Black: ECE/TRANS/WP.29/GRSP/2014/15
Blue: ECE/TRANS/WP.29/GRSP/2014/30
Green: GRSP-60-17
Red: proposed changes

Global technical regulation No. 9 (Pedestrian safety) – Proposal for Phase 2 of the global technical regulation

Draft amendment 2 – Revision 1

Submitted by the Informal Working Group on global technical regulation No. 9*

"Figure 12

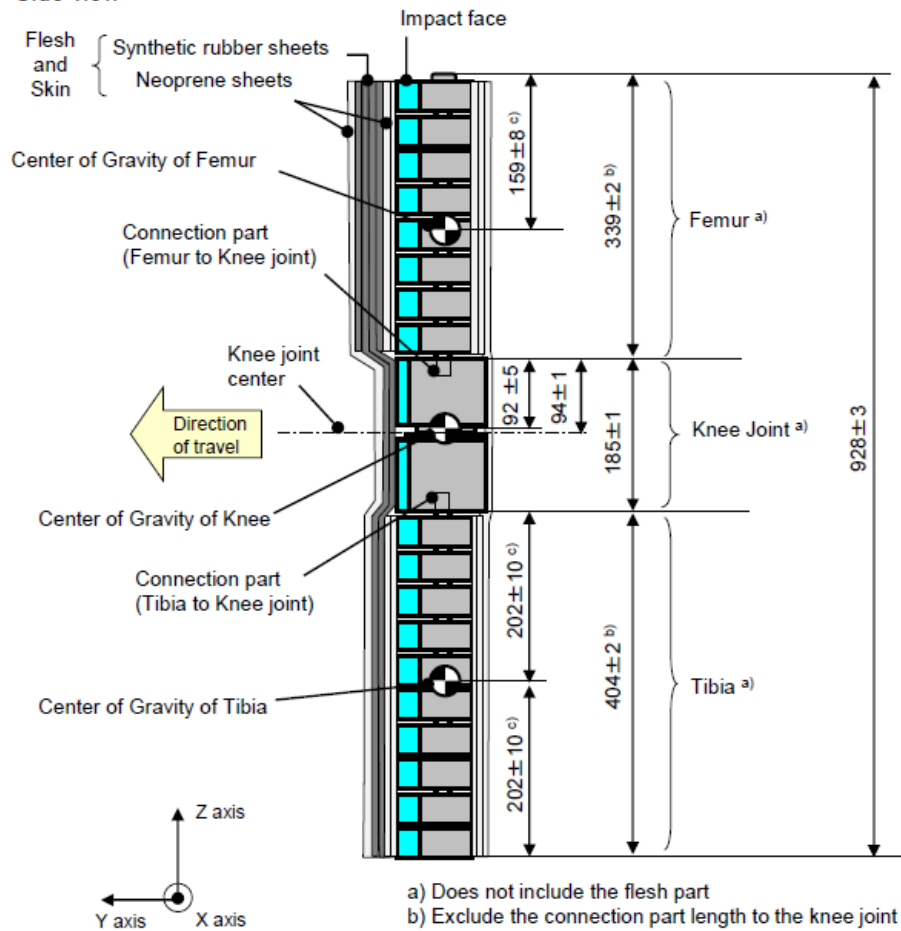
The flexible lower legform impactor shall consist of the flesh and skin, the flexible long bone segments (representing the femur and the tibia), and the knee joint as shown in Figure 12.

The centres of gravity of the femur and tibia without the flesh and skin, including the connection parts to the knee joint, shall be 159 ± 8 mm and 202 ± 10 mm respectively from the top, but not including the connection part to the knee joint, of each part as shown in Figure 12. The centre of gravity of the knee joint shall be 92 ± 5 mm from the top of the knee joint as shown in Figure 12.

Figure 13

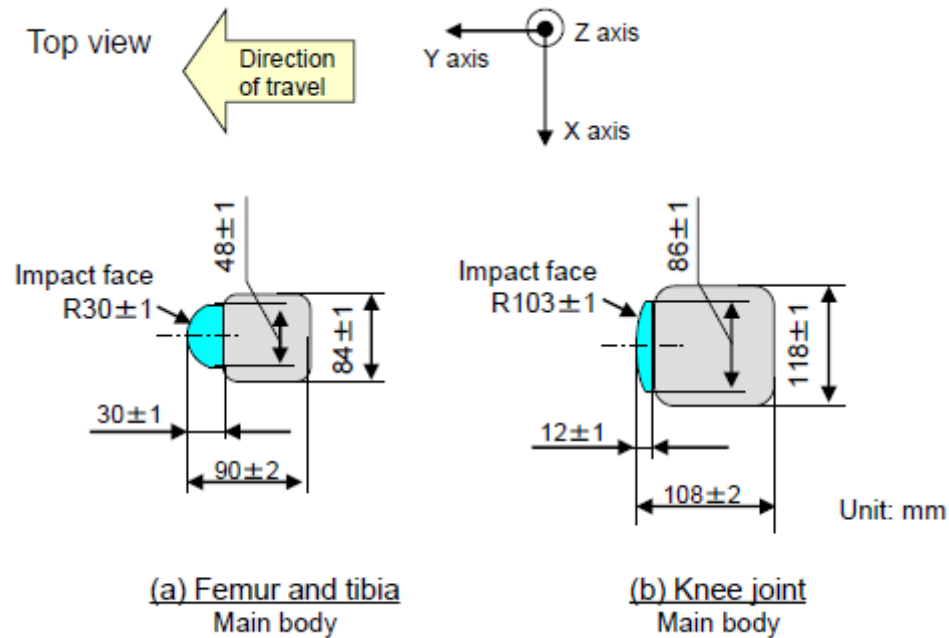
- 6.3.1.1.1. The cross-sectional shape perpendicular to the Z-axis of the femur and the tibia main body segments shall be 90 mm in width along the Y-axis, and 84 mm in width along the X-axis as shown in Figure 13 (a). The impact face shall be 30 mm in radius, 30 mm in width along the Y-axis, and 48 mm in width along the X-axis as shown in Figure 13 (a).

- 6.3.1.1.2. The cross-sectional shape perpendicular to the Z-axis of the knee joint shall be 108 mm in width along the Y-axis, and 118 mm in width along the X-axis as shown in Figure 13 (b). The impact face shall be 103 mm in radius, 12 mm in width along the Y-axis, and 86 mm in width along the X-axis as shown in Figure 13 (b).

Figure 14

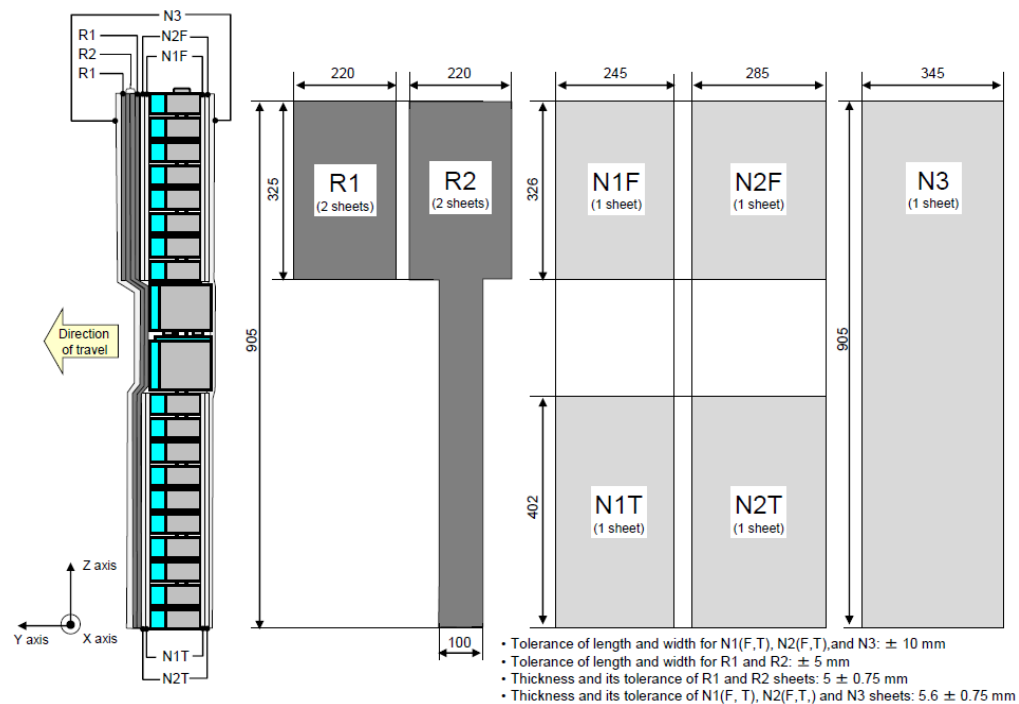
- 6.3.1.1.4. For each test, the impactor (femur, knee joint and tibia) shall be covered by the flesh and skin composed of synthetic rubber sheets (R1, R2) and neoprene sheets (N1F, N2F, N1T, N2T, N3) as shown in Figure 14. The size of the sheets shall be within the requirements described in Figure 15. The sheets are required to have compression characteristics as shown in Figure 15. The compression characteristics shall be checked using

Figure 16
Flexible lower legform impactor; Instrument

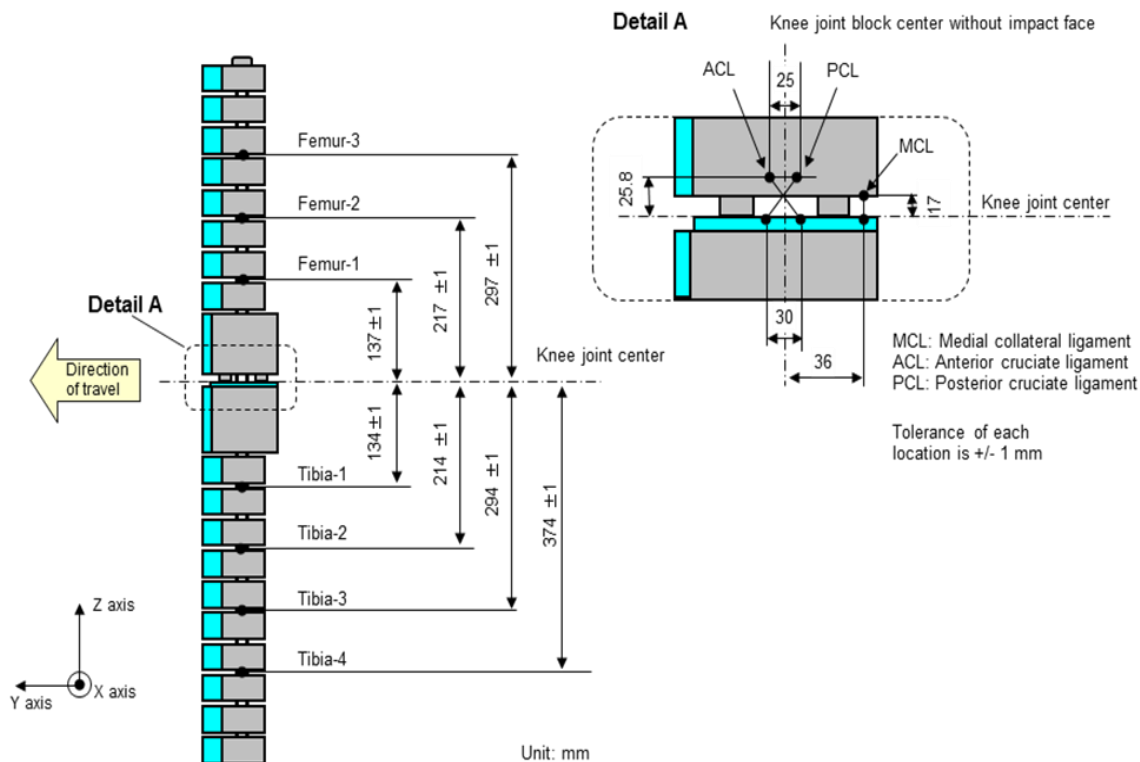
- 6.3.1.1.6.1. **Four transducers shall be installed in the tibia to measure bending moments at locations within the tibia. The sensing locations of each of the transducers are as follows: tibia-1: 134 mm, tibia-2: 214 mm, tibia-3: 294 mm and tibia-4: 374 mm below the knee joint centre respectively as shown in Figure 16.**

Three transducers shall be installed in the femur to measure bending moments applied to the femur. The sensing locations of each of the transducers are as follows: femur-1: 137 mm, femur-2: 217 mm and femur-3: 297 mm above the knee joint centre, respectively, as shown in Figure 16.

"Figure 20

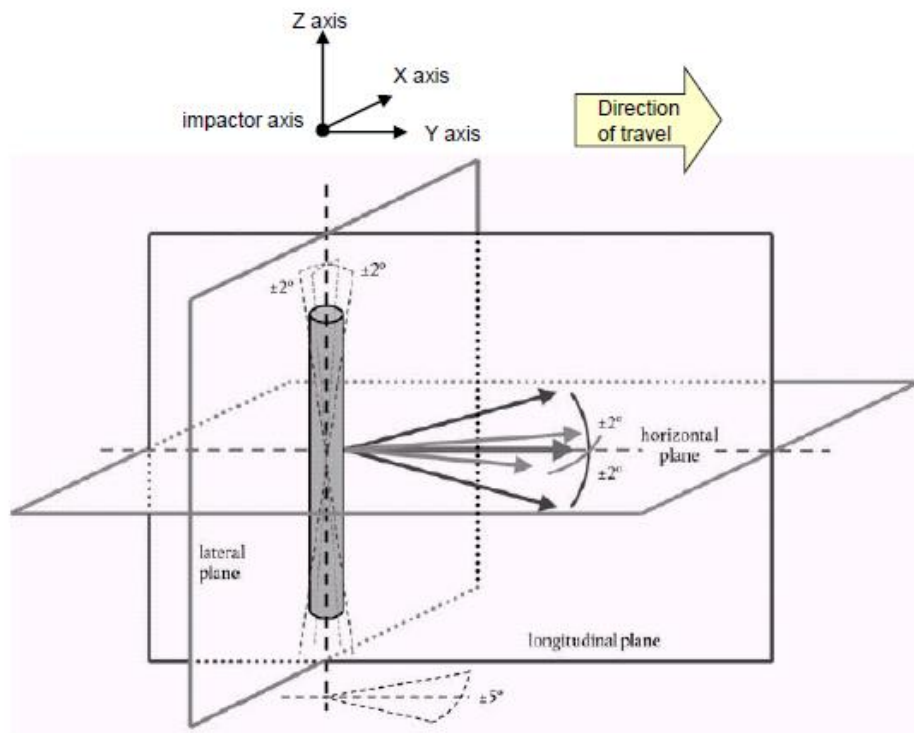
7.1.1.2. **The direction of the impact velocity vector shall be in the horizontal plane and parallel to the longitudinal vertical plane of the vehicle. The tolerance for the direction of the velocity vector in the horizontal plane and in the longitudinal plane shall be $\pm 2^\circ$ at the time of first contact. The axis of the impactor shall be perpendicular to the horizontal plane, with a roll and pitch angle tolerance of $\pm 2^\circ$ in the lateral and longitudinal plane. The horizontal, longitudinal and lateral planes are orthogonal to each other (see Figure 20).**

- 7.1.1.3.2. At the time of first contact the impactor shall have the intended orientation about its vertical axis, for the correct operation of its knee joint, with a yaw angle tolerance of $\pm 5^\circ$ (see Figure 20).

Figure 21

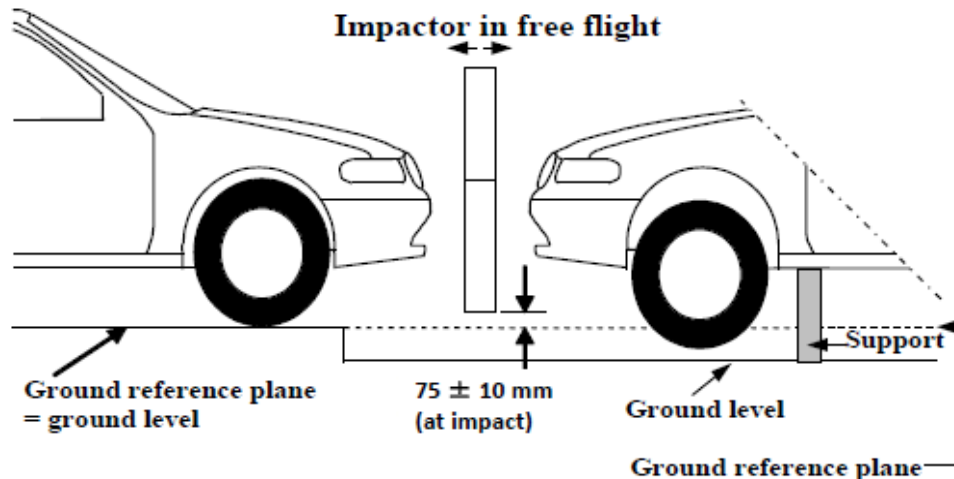
7.1.1.3. **The bottom of the impactor (without parts needed for the purposes of launching and/or protection) shall be 75 mm above the ground reference plane at the time of the first contact with the bumper (see Figure 21), with a tolerance of ± 10 mm. When setting the height of the propulsion system, an allowance must be made for the influence of gravity during the period of free flight of the impactor.**

Figure 22

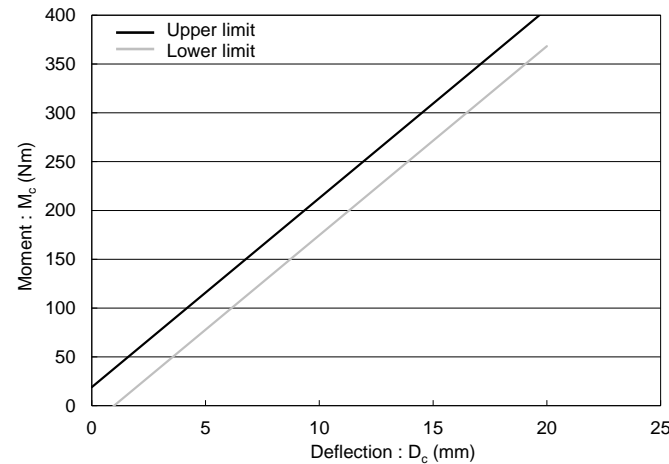
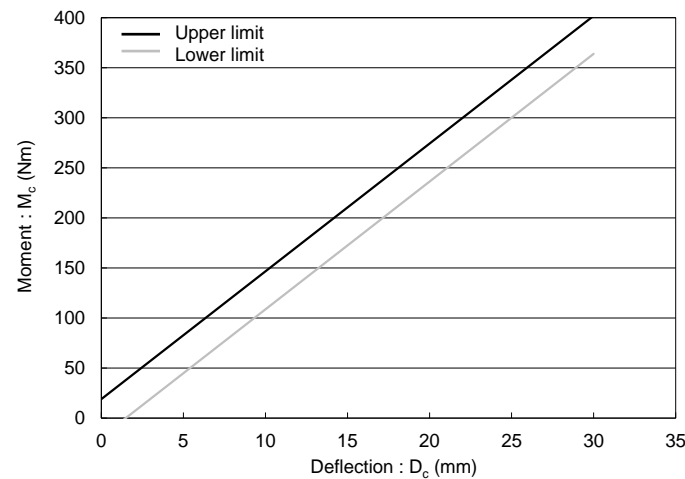
- 8.1.1.2. **When the femur and the tibia of the impactor are loaded in bending in accordance with paragraph 8.1.1.4., the applied moment and the generated deflection at the centre of the femur and the tibia (M_c and D_c) shall be within the corridors shown in Figure 22.**

Figure 23

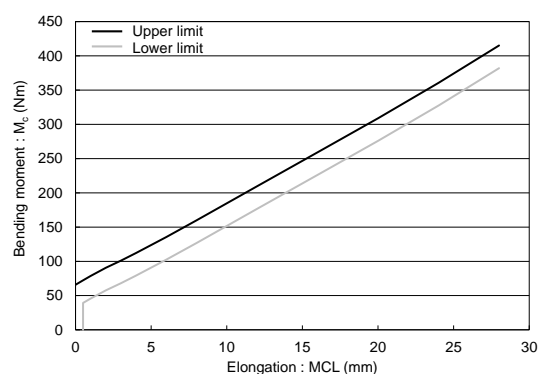
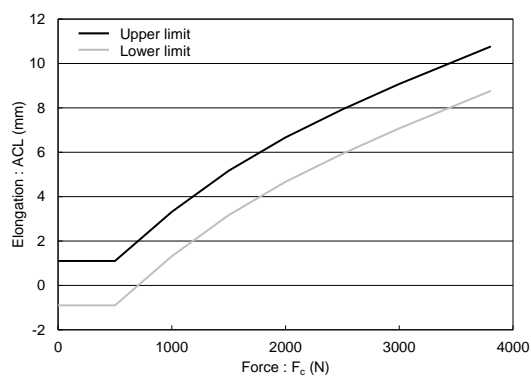
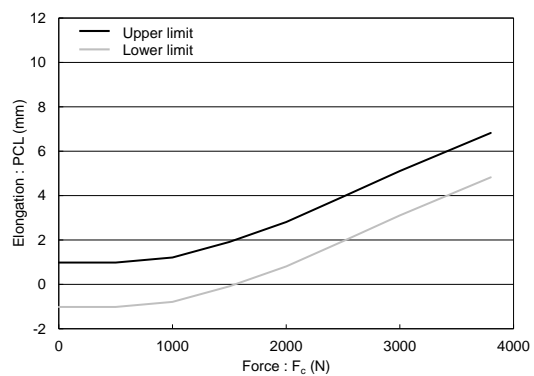
- 8.1.1.3. **When the knee joint of the impactor is loaded in bending in accordance with paragraph 8.1.1.5., the MCL, ACL, and PCL elongations and applied bending moment or the force at the centre of the knee joint (M_c or F_c) shall be within the corridors shown in Figure 23.**

Figure 24

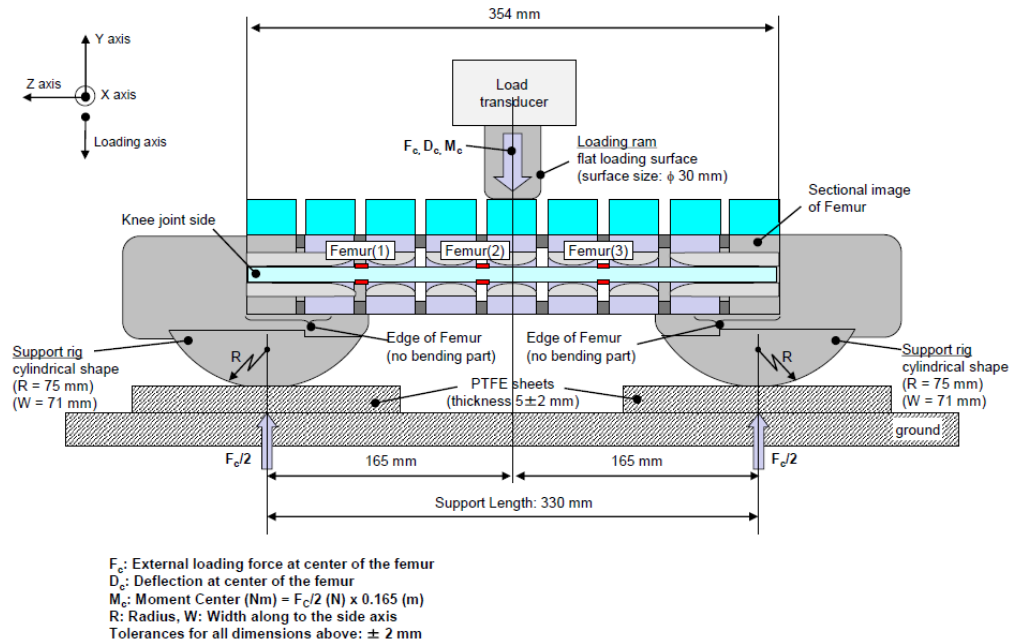
- 8.1.1.4. **The edges of the femur and tibia, not bending parts, shall be mounted to the support rig firmly as shown in Figure 24 and Figure 25. The Y-axis of the impactor shall be parallel to the loading axis within $180 \pm 2^\circ$ tolerance. To obtain repeatable loading, low friction Polytetrafluoroethylene (PTFE) plastic pads are used under each support (see Figures 24 and 25).**

Figure 26

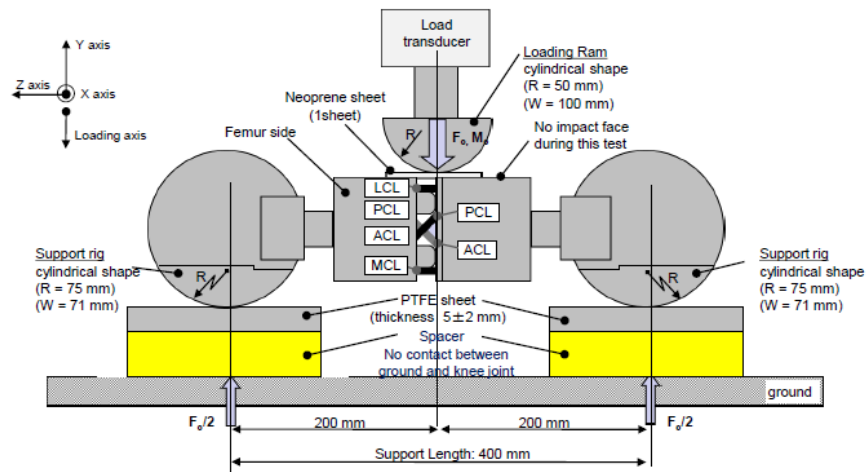
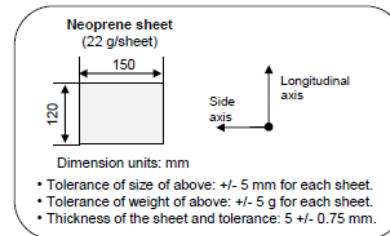
- 8.1.1.5. The ends of the knee joint shall be mounted to the support rig firmly as shown in Figure 26. The Y-axis of the impactor shall be parallel to the loading axis within $\pm 2^\circ$ tolerance. To obtain repeatable loading, low friction Polytetrafluoroethylene (PTFE) plastic pads are used under each support (see figure 26). To avoid impactor damage, a neoprene sheet shall be set underneath the loading ram and the impactor face of the knee joint which is described in the Figure 13 shall be removed. The neoprene sheet used in this test shall have compression characteristics as shown in Figure 15.

The centre of the loading force shall be applied at the knee joint centre within $\pm 2^\circ\text{mm}$ tolerance along the Z-axis (see figure 12). The external load shall be increased so as to maintain a deflection rate between 10 and 100 mm/minute until the bending moment at the centre part of the knee joint (M_c) reaches 400 Nm.

Figure 27
Flexible lower legform impactor: Test set-up for the dynamic lower legform impactor certification test (pendulum test, see paragraph 8.1.2.4.)

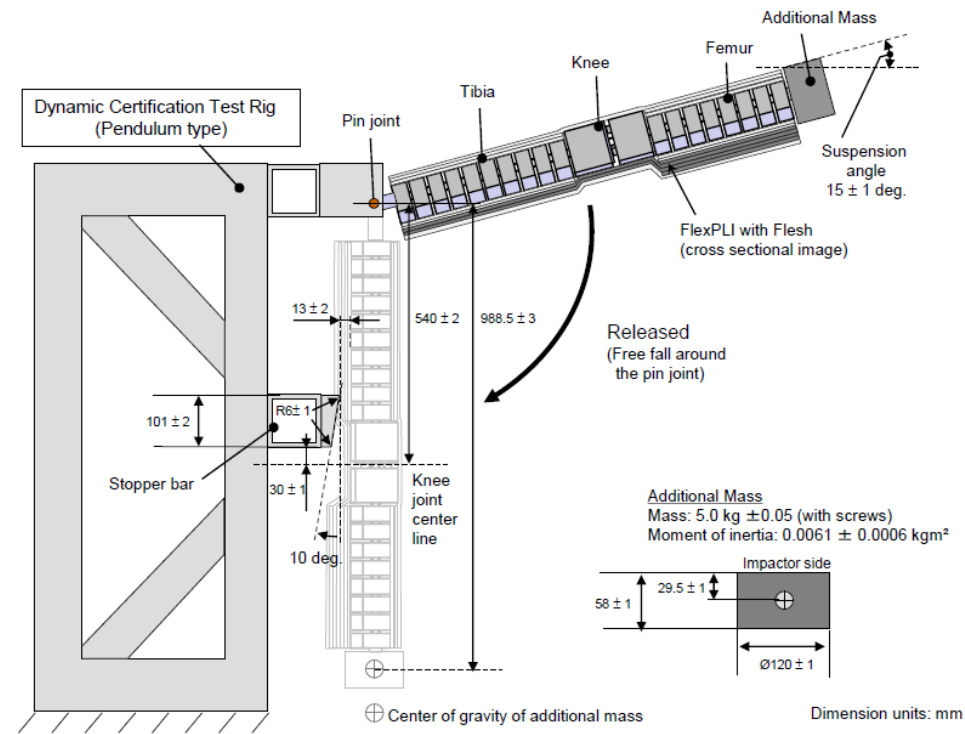
- 8.1.2.4.1. The flexible lower legform impactor, including the flesh and skin, shall be suspended from the dynamic certification test rig $15 \pm 1^\circ$ upward from the horizontal as shown in Figure 27. The impactor shall be released from the suspended position and fall freely against the pin joint of the test rig as shown in Figure 27.

- 8.1.2.4.2. The knee joint centre of the impactor shall be 30 ± 1 mm below the bottom line of the stopper bar, and the tibia impact face without the flesh and skin shall be located 13 ± 2 mm from the front upper edge of the stopper bar when the impactor is hanging freely as shown in Figure 27.

Figure 28

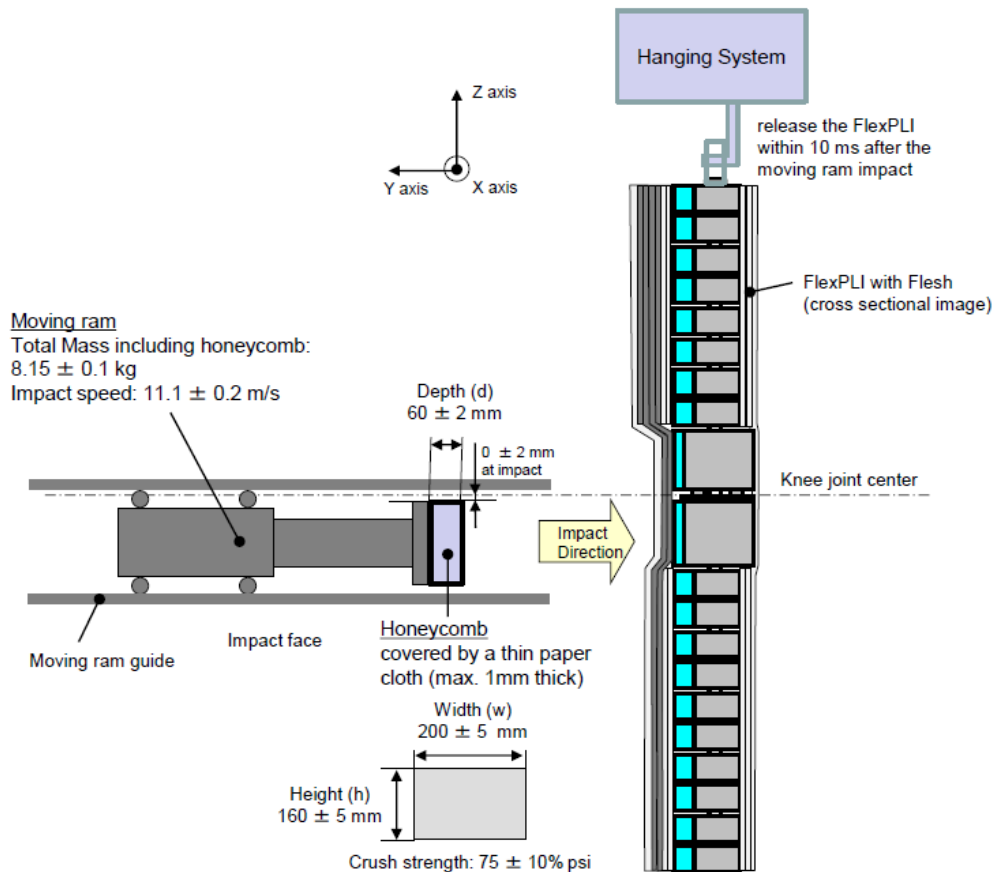
- 8.1.3.4. Test procedure
 - 8.1.3.4.1. The assembled flexible lower legform impactor (with the flesh and skin) shall be hung vertically and freely suspended from a test rig as shown in Figure 28. It is then impacted by the upper edge of a linearly guided aluminium honeycomb impactor, covered by a thin paper cloth with a maximum thickness of 1 mm, at an impact speed of 11.1 ± 0.2 m/s. The legform shall achieve a free flight condition within 10 ms after the time of first contact of the honeycomb impactor.
